New Model Introduction

New model GR-6500-000 is offered as a direct replacement for model GC25584M. Models have common mounting and tooling and are dimensionally the same.

Gen 5 Model GR-6500-000

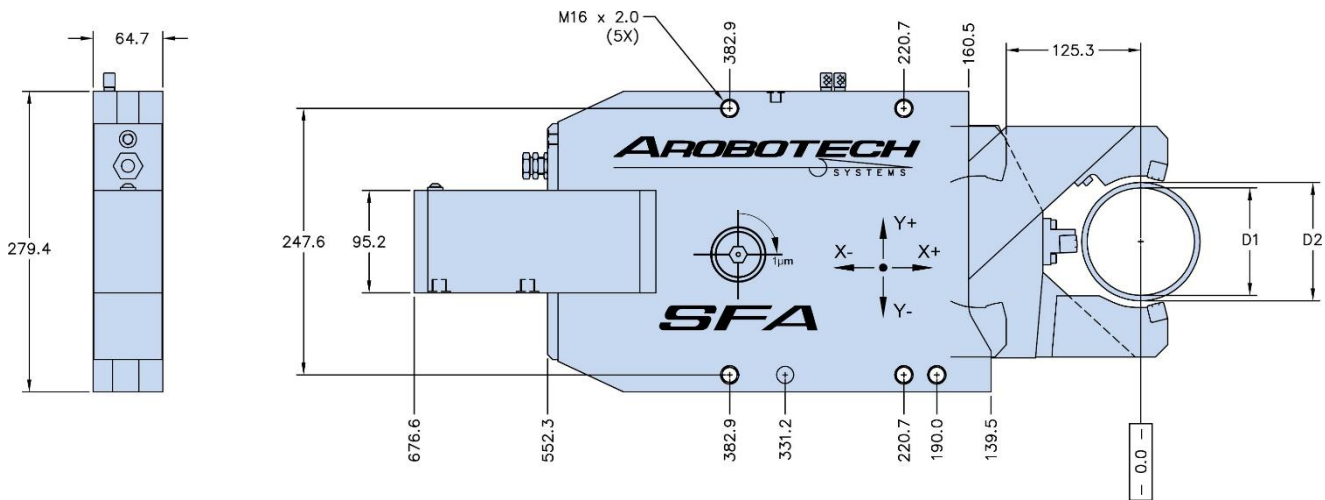
- * Max Clamp Size = 120mm Diameter
- * 20.3 cm² Piston Area
- * 90° Turn = 0.001mm Adjustment (both axis)
- * +/- 0.200mm Total Adjustment (both axis)

- * Max Clamp Size = 120mm Diameter
- * 20.3 cm² Piston Area
- * X-Axis = 6.5° Turn = 0.001mm Adjustment ▪ ±0.22mm Total Adjustment
- * Y-Axis = 9.0° Turn = 0.001mm Adjustment ▪ ±0.07mm Total Adjustment
